6641A-07

Modification Recommended Service Note

6641A DC power supply, 0-8 V, 0-20 A, 160 W. GPIB

Serial Numbers: MY53000140 to MY53000698 and SG53000101 to SG53000108

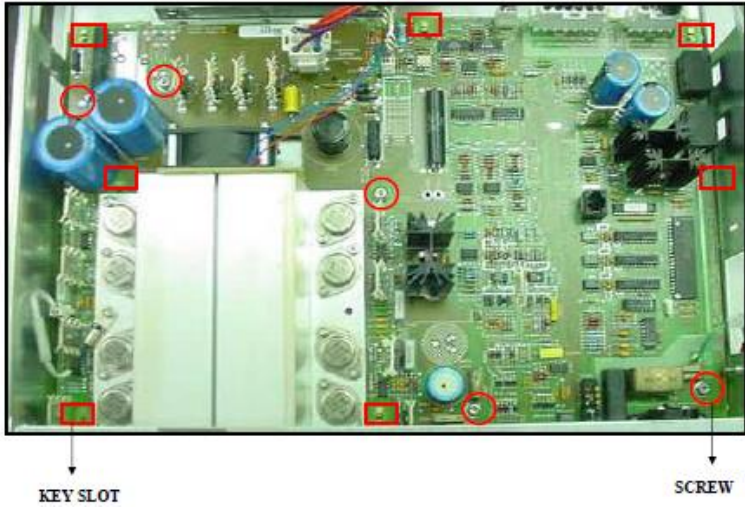
The Problem – 6641A exhibited out of specification values for 3.8V to 4.2V at front panel read back readings.

6641A exhibited out of specification values for 3.8V to 4.2V at front panel read back readings. Other ranges and remote programming's behaved normally.

7. Replace with a new PCA board (06641-61030)
